UNITED STATES PATENT AND TRADEMARK OFFICE

Office Action Summary

10/706,965

PUGSLEY ET AL.

FIG. 2B

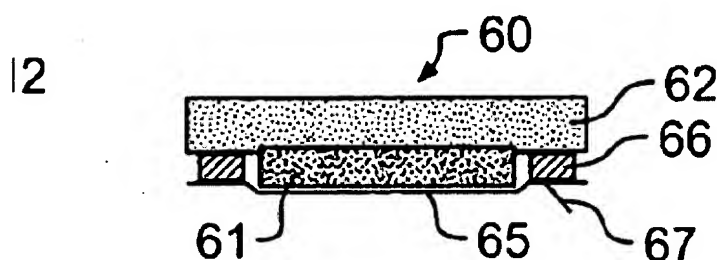
a prior art reference disclosing the structural limitations of the claim, see *In re Pearson*, 494 F.2d 1399, 181 USPQ 641 (CCPA 1974). Examiner further asserts that Applicant's own drawings do not disclose the argued recitation as shown in the reproduced figure below. As shown below, the protective liner does not have any direct contact with the implant.
